Letter in opposition to [3520 S Street NW](#)
Re: Case # 19521A

Board of Zoning Adjustment
District of Columbia
CASE NO. 19521A
EXHIBIT NO. 52

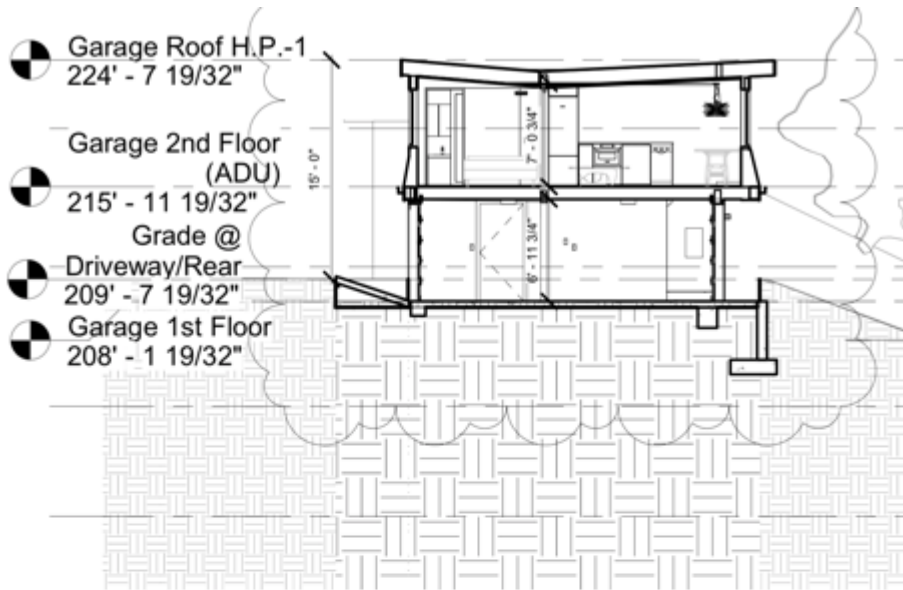
The mere size of 15' structure which is much larger than the average 10' garage in our alleys changes the look of the alleys completely. It is intrusive. Houses that have additions to the rear usually have the view and living area in the rear of the house. The 2nd floor windows of these ADU's will look onto and into both the back yards and the back of the houses. It is a clear and unnecessary invasion of privacy.

Below is a picture of what a 15' high "garage" looks like compared to the garages throughout Burleith. This is an example of an illegal garage/adu with a stop work order in place as seen from my deck.

01 PROPOSED-SECTION
 SCALE 3/32" = 1'-0"

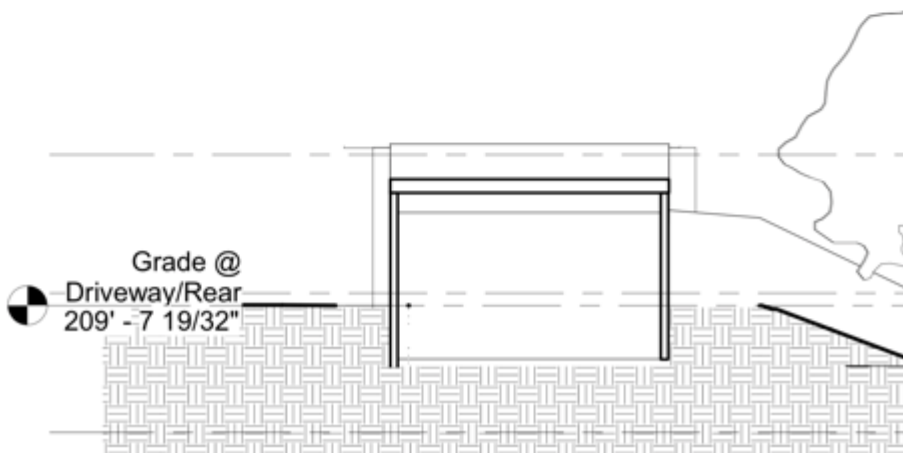
This particular application should be denied because the garage is 16.5 feet from the measurement point specified in the Regulations (D5002.1) as the "finished grade at the middle of the side of the accessory building that faces the main building...". In the R20 zone, the maximum height is 15'. In the attempt to get around the R-20 zoning regulations, this sunken structure will be inappropriate and unsightly. It will be 18" below alley and back yard grade. That could be a safety issue. It will look massive and equally dissimilar to all other structures in the alleys of Burleith. This structure is about 70% of the square footage of the main structure.

This is the proposed sunken structure. It is set 1.5 feet (18“) below alley and yard grade.
